PHASE I INSPECTION REPORT  
NATIONAL DAM SAFETY PROGRAM

MAPLE GROVE RESERVOIR DAM  
JEFFERSON COUNTY, COLORADO  
DIVISION I  
DISTRICT 7

OWNER: CONSOLIDATED MUTUAL WATER COMPANY

INSPECTED: AUGUST 6, 1979

Photo No. 1 Crest of Maple Grove Dam, looking west.  
Note erosion and depression at right bridge abutment.

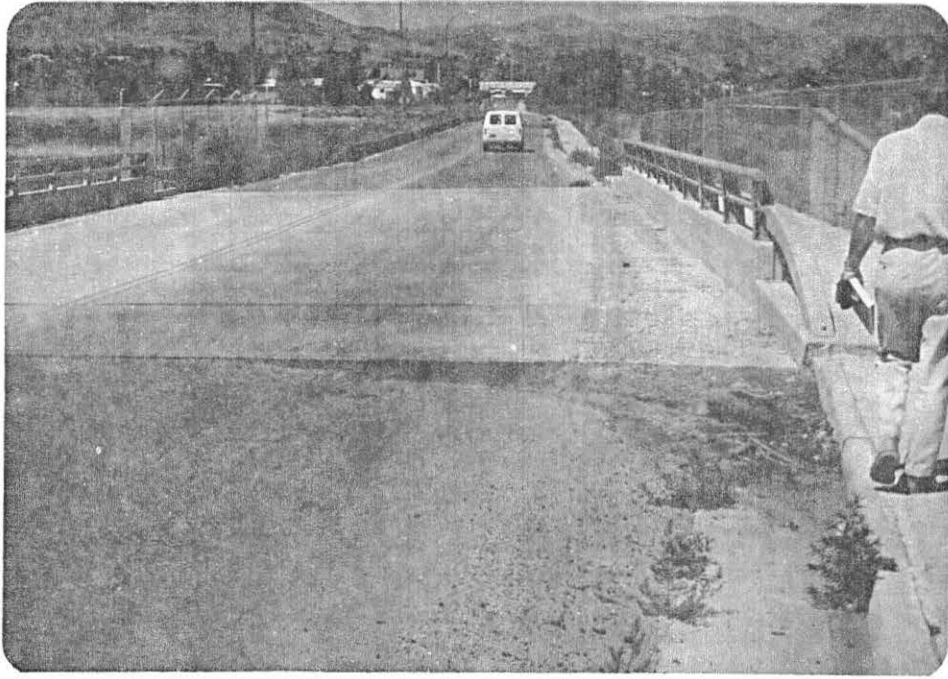
- a. The City of Lakewood, which has the maintenance responsibilities for W. 27th Avenue, should be notified in writing that the pavement surface is deteriorating and its resurfacing should be given a high priority on their schedule.

Photo No. 9 Manual operation of the gate screw. Slope of the embankment prevents full turning of the gear with handle.

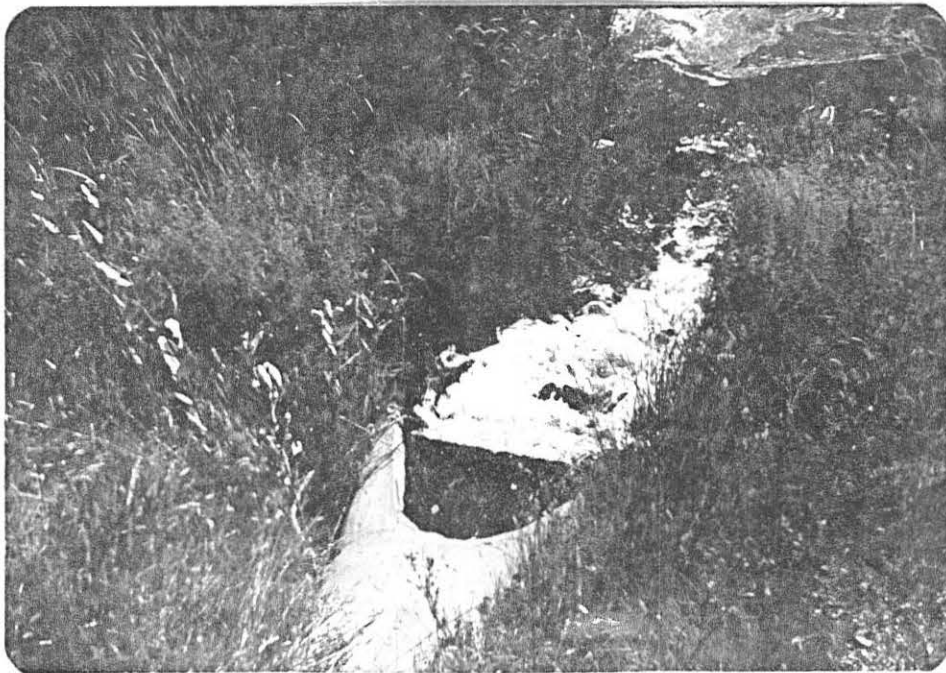
- E. Outlet Works. On the day of inspection the outlet was open, as it is at all times, with water flowing through the conduit and into the stilling basins of the water filtration plant. Because this is a continuous use filter plant, it is not practical to close down the outlet completely unless signs of distress in the embankment would warrant a more thorough inspection. However, the manually operated gate screw located above the outlet conduit was exercised for several turns. The screw turned without difficulty, however, a common pipe wrench, rather than the gear handle had to be used due to the lack of space between the gear stem and the slope of the embankment. (See Photo No. 9).

- d. The upstream gate control on the outlet works should be secured in an open position to prevent unauthorized closure.
  - e. The outlet works conduit and the Rocky Mountain Ditch culvert through the embankment should be periodically inspected to determine if any leakage is present. Soil resistivity in these areas should be checked to estimate the life expectancy of the pipe material.
